# PRODUCT BULLETIN

**Bulletin No:** PB374

NEW G2 Series Blades for the HAKKO FT-801 Thermal Wire Stripper

G2-A1601, G2-A1602, G2-A1603

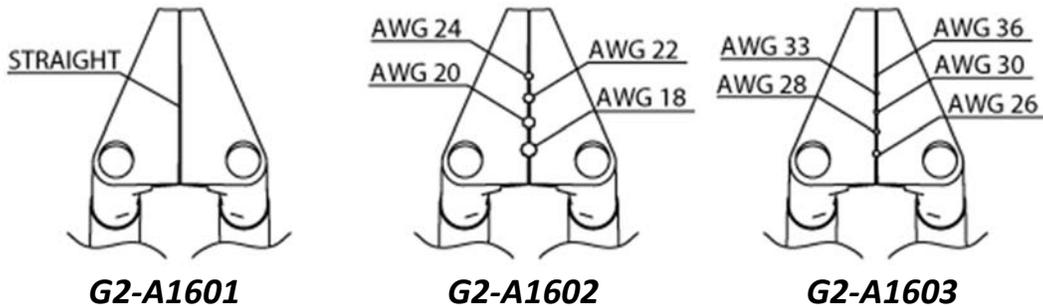
These new G2 Blade Sets for the HAKKO FT-801 Thermal Wire Stripper include a wishbone support between them that is attached to the collar. This support mitigates rotational play in the blades to improve notch alignment at the end of the blades when tighter tolerances are required.
